**Intel® Pentium® 4 Processor in
478-pin Package and Intel®
845/845E/845G/845GL/845GV/
845GE/845PE Chipset**

**Platform Design Guide Addendum

For Support with Intel® Celeron® D
Processor in 478-pin Package**

Revision 1.1

Figure 1. Socket Sense Circuit

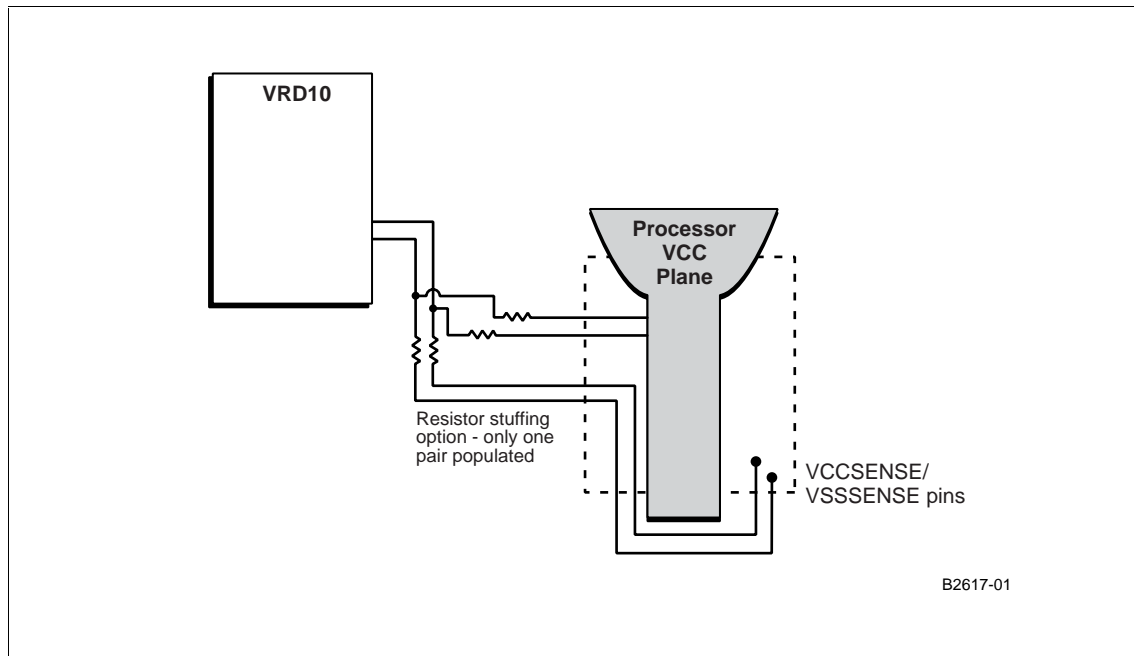
The compatible platform should have additional routing from the VRD 10.0 to the processor and resistor stuffing options should be used to select socket sense option.

Figure 2. Bi-Directional PROCHOT# Circuit

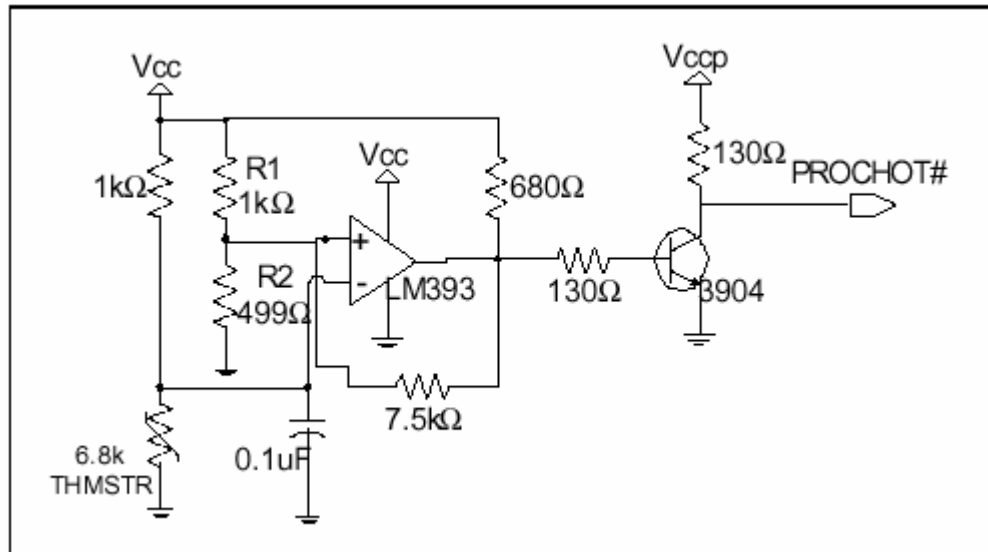
Intel recommends that the compatible system boards be designed to support the Intel Celeron D processor in the 478-pin package. These guidelines include an ICC_MAX and a VR_TDC (VR Thermal Design Current). The processor voltage regulator (VR) solution should be designed to support ICC_MAX electrically for brief time periods. The voltage regulator solution should also be designed to support a minimum of VR_TDC indefinitely within the envelope of system operating conditions. The VR_TDC limits of the system board are typically governed by the system board thermal limits. Intel recommends that system boards designed to the above guidelines implement a VR thermal monitor circuit.

For this circuit implementation, the thermistor (THMSTR) should be placed in the hottest area of the VR. As the thermistor heats up, its resistance goes down. This creates an error voltage based on the resistance of the thermistor and the voltage reference provided by R1 and R2. The values of R1 and R2 should be adjusted to calibrate the circuit for a specific system board design so that it asserts PROCHOT# when the VR reaches its thermal limit. The values of R1 and R2 in Figure 2 are included as an example. The value of R2 is adjusted to calibrate the circuit so that PROCHOT# is asserted when the VR reaches its thermal limit in the system that it is intended to operate in. An adequate VR cooling solution should be implemented such that VR_TDC current levels can be maintained indefinitely.

Figure 3. VRD Feedback Switching Diagram

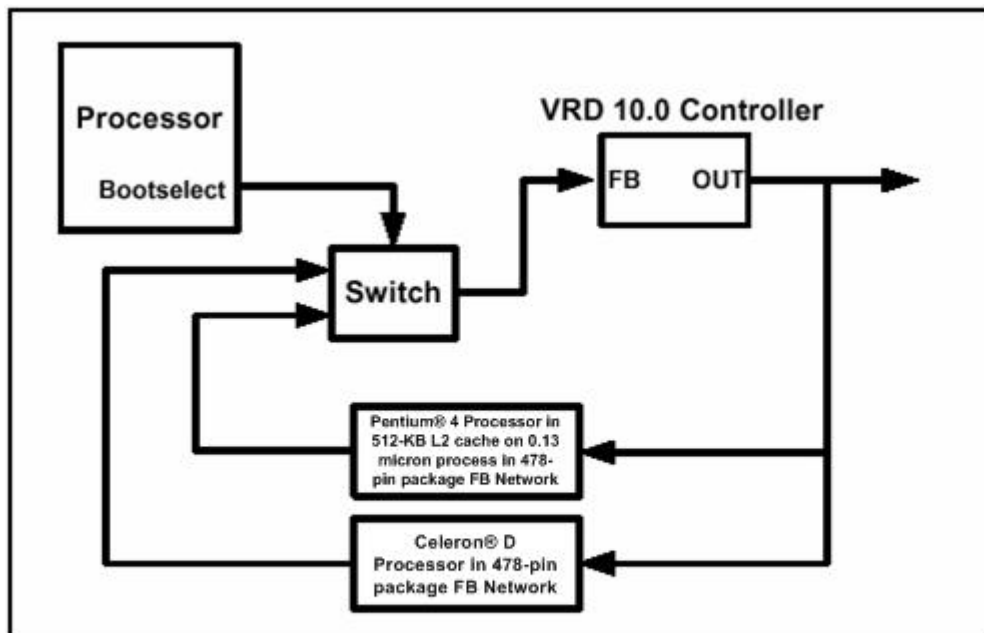
The Intel® Celeron® D Processor in the 478-pin package and the Intel® Pentium® 4 processor with 512-KB L2 cache on 0.13 micron process have different loadline requirements. Therefore, the VRD 10.0 controller must switch feedback networks depending on which processor is installed. The BOOTSELECT signal is used by the VRD to detect whether an Intel Celeron D processor in the 478-pin package or Intel Pentium 4 processor with 512-KB L2 cache on 0.13 micron process is inserted into the processor socket and switches the feedback network. Figure 3 shows a diagram of the switching network, while Figure 4 shows an example of the switching circuit.

Figure 5. Reset Timing Circuit - 1

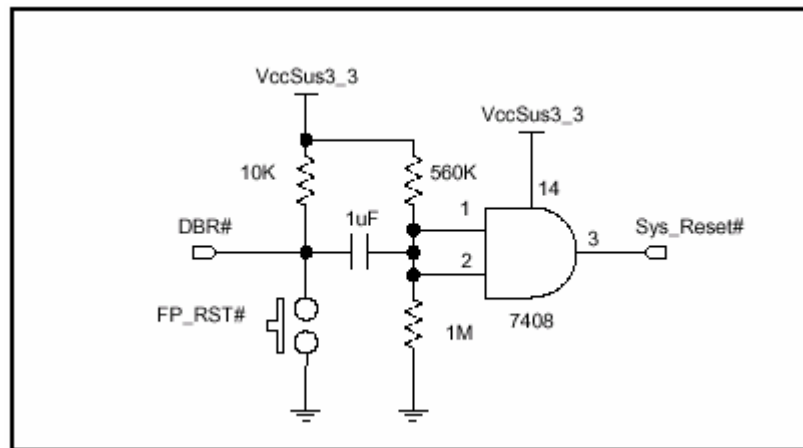
If restarting the system after a shutdown caused by a catastrophic thermal event (THERMTRIP# event) and in order to protect the Intel Celeron D processor in the 478-pin package during the reset state, there are two reset timing requirements that have to be met: CPUPWRGD active to CPURST inactive, and VCC_CPU active to CPUPWRGD assertion.

The front-panel reset switch (FP_RST #) is connected to SYS_RESET# to reset the whole system. The reset timing may violate the system stability conditions. To prevent this condition, the following two schematics are recommended to generate a 20 ms \pm 20% pulse reset signal. Compatible platforms should implement either of the two timing circuits shown in Figure 5 or Figure 6.

Figure 7. Voltage Translation of INIT#

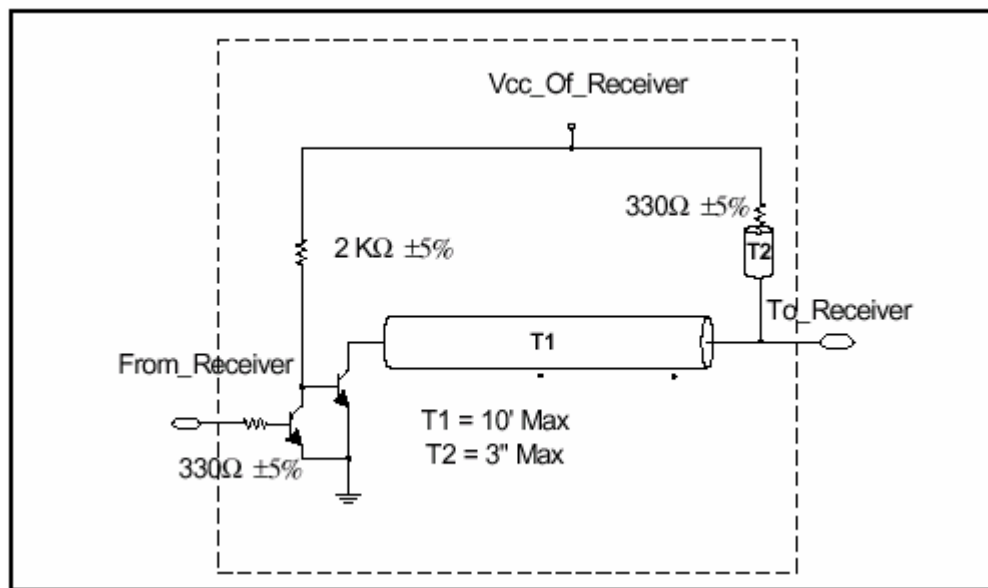
The recommended logic circuit for level shifting the INIT# signal has changed. The lower processor VID has led to changes in the circuit and input resistor values.

Figure 8. Voltage Sequence Block Diagram

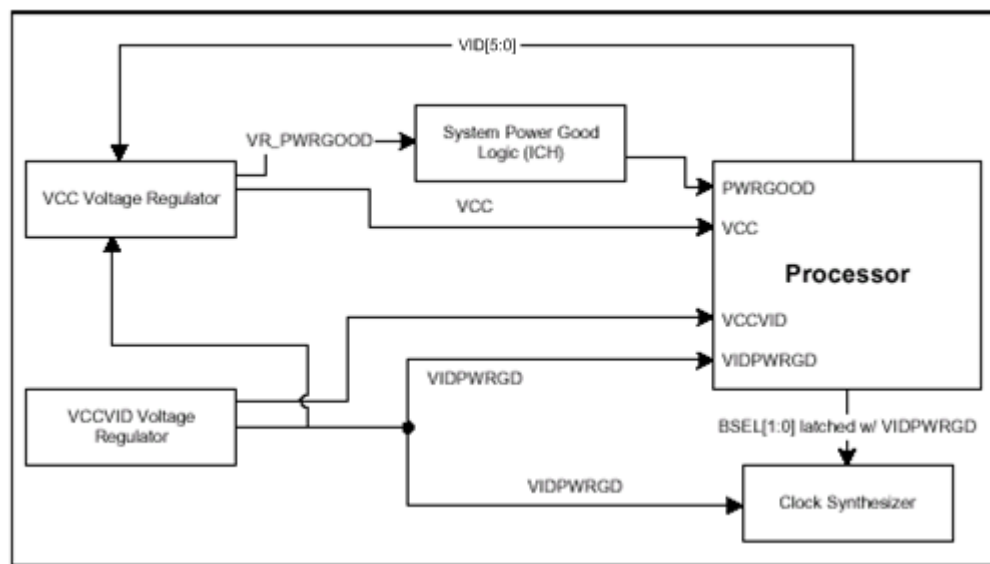
To support the Intel Celeron D processor in the 478-pin package, there are additional power sequencing requirements. This is mainly due to the addition of a VIDPWRGD input to the Intel Celeron D processor in the 478-pin package. This input is designed to indicate when the VCCVID voltage is stable and the processor is able to drive the VID[5:0] outputs. A block diagram of an example implementation is shown in Figure 8.
